SUBDIVISION COMMITTEE
METROPOLITAN AREA PLANNING
COMMISSION

STAFF REPORT
(Preliminary Plat)

CASE NUMBER: S/D 88-27 - HEATHER RIDGE ADDITION

Re: FINAL - S/D 88-27 - HEATHER RIDGE ADDITION

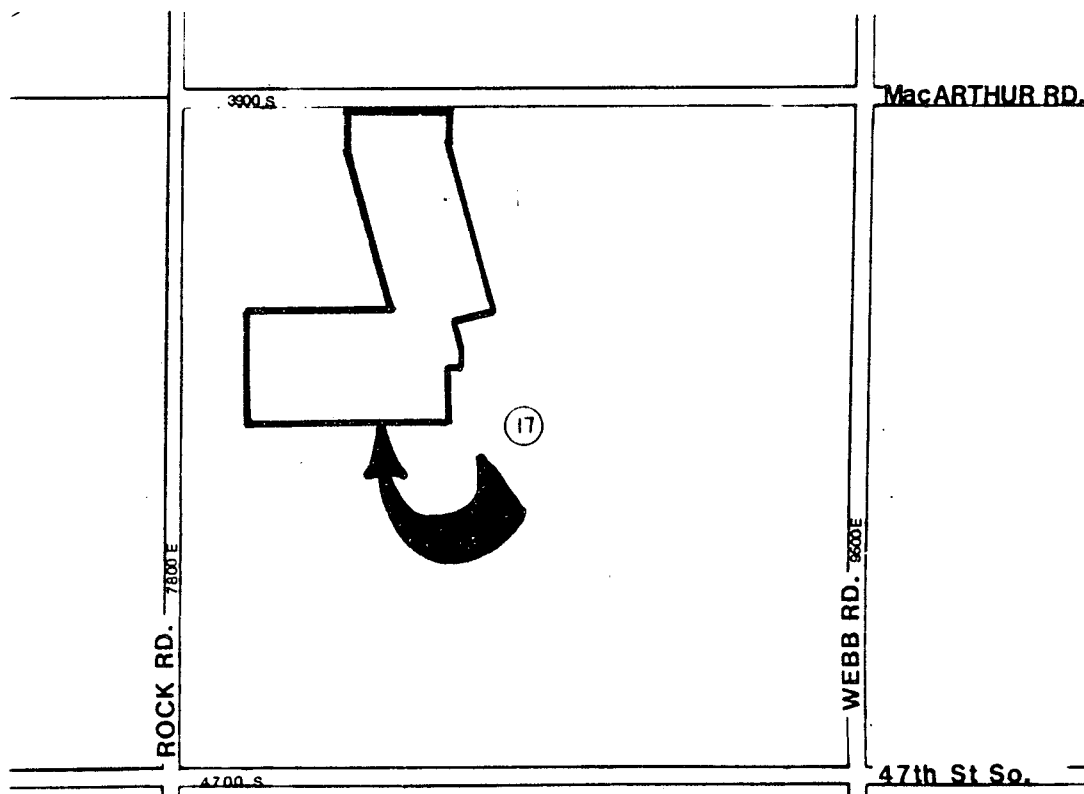
- A. Since neither municipal water nor sanitary sewer is available to serve this property, the applicant shall contact the Environmental Health Division of the Health Department to find out what tests may be necessary and what standards are to be met for approval of on-site sewerage facilities and water wells. A memorandum shall be obtained specifying approval.

- B. The applicant shall guarantee the construction of the proposed interior streets to the standards of a suburban street.
- C. On the final plat, the platator's text shall make appropriate reference to the platting of the temporary cul-de-sac easement. This wording shall clearly state that the temporary easement expires upon extension of 42nd Street South to the west.

- D. Prior to, or at the time of submitting the final plat, the applicant shall submit a drainage plan to County Engineering for review and approval.
- E. To receive mail delivery without delay, and to avoid unnecessary expense, the applicant is advised of the necessity to meet with the U.S. Postal Service Growth Management Coordinator (phone 316-946-4527) prior to development of the plat so that the type of delivery, and the tentative mailbox locations can be determined.

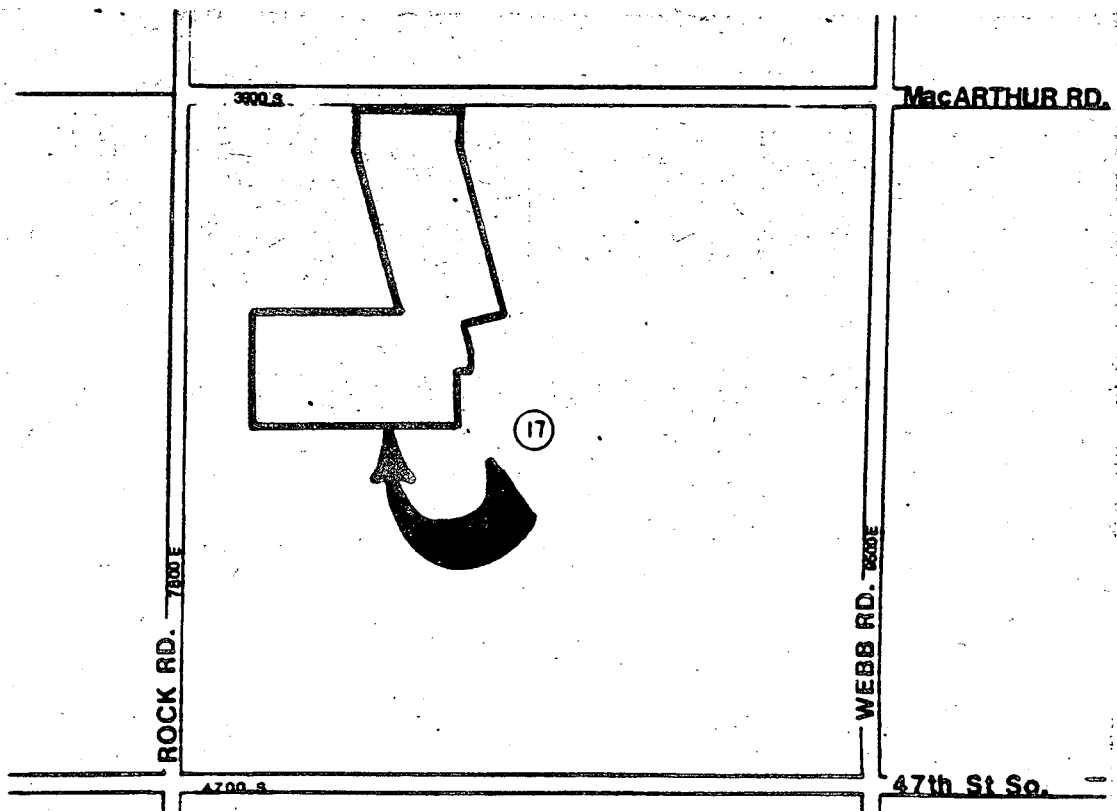
- NOTE: This plat was deferred two weeks from the May 5, 1988 Subdivision Committee meeting to allow the applicant time to consider the County's request that 42nd Street South be extended all the way westward to Rock Road.

- B. The applicant shall guarantee the construction of the proposed interior streets to the standards of a suburban street.
 - C. On the final plat, "complete access control" shall be indicated from the two northerly-most lots to MacArthur Road.

- D. The plat's text shall be amended to state that the access controls are being dedicated to the appropriate governing body.
 - E. To receive mail delivery without delay, and to avoid unnecessary expense, the applicant is advised of the necessity to meet with the U.S. Postal Service Growth Management Coordinator (phone 316-946-4527) prior to development of the plat so that the type of delivery, and the tentative mailbox locations can be determined.

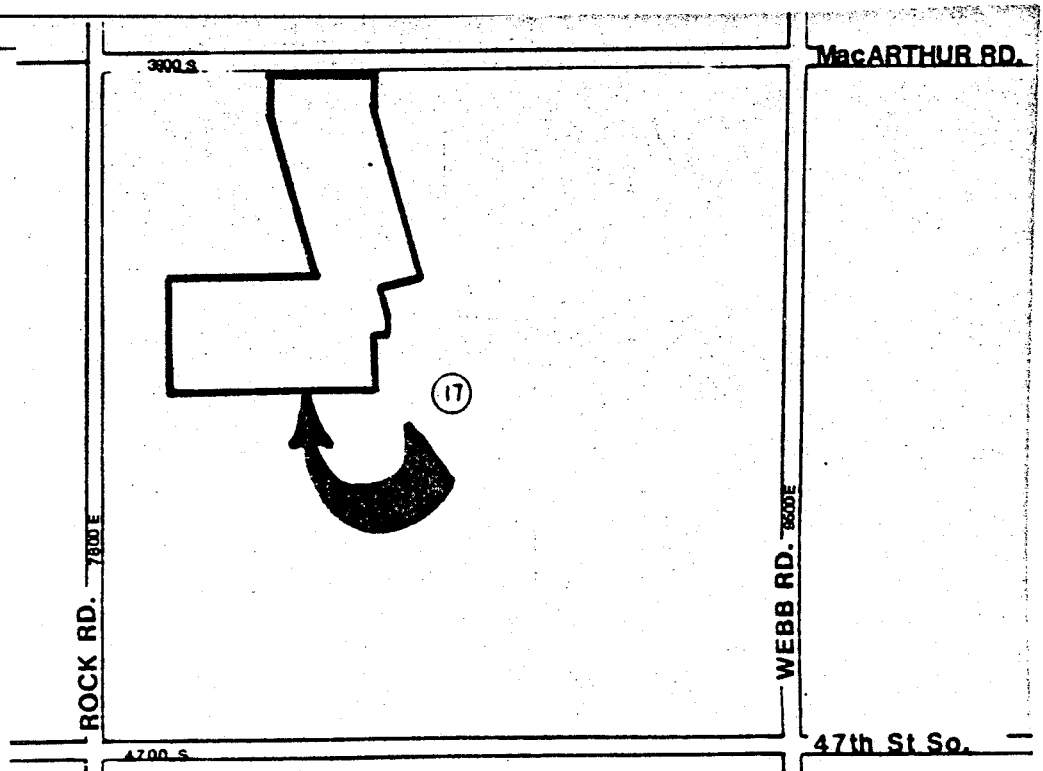
NOTE: This plat was indefinitely deferred at the May 19, 1988, Subdivision Committee meeting to allow the applicant time to consider the County's request that 42nd Street South be extended west to Rock Road.

- B. The applicant shall guarantee the construction of the proposed interior streets to the standards of a suburban street.
- C. The applicant shall guarantee any drainage improvements required by the platting of this property.

- D. The applicant shall submit an avigational easement covering all of subject plat and a restrictive covenant assuring that adequate construction methods will be used to minimize the effects of noise pollution in the habitable structures constructed on subject property.

- E. On the final plat, "complete access control" shall be indicated to MacArthur Road from Lot 1, Block A and Lot 1, Block B.
- F. The plattor's text shall be amended to state that the access controls are being dedicated to the appropriate governing body.

- G. In order to avoid leaving a strip of unplatted property to the west of this plat, and in order to provide a street connection from this plat to Rock Road, the applicant shall submit a redesigned plat which depicts the platting of a north/south street to connect 42nd Street South with Rock Road Court, as proposed by Heather Ridge 2nd Addition.
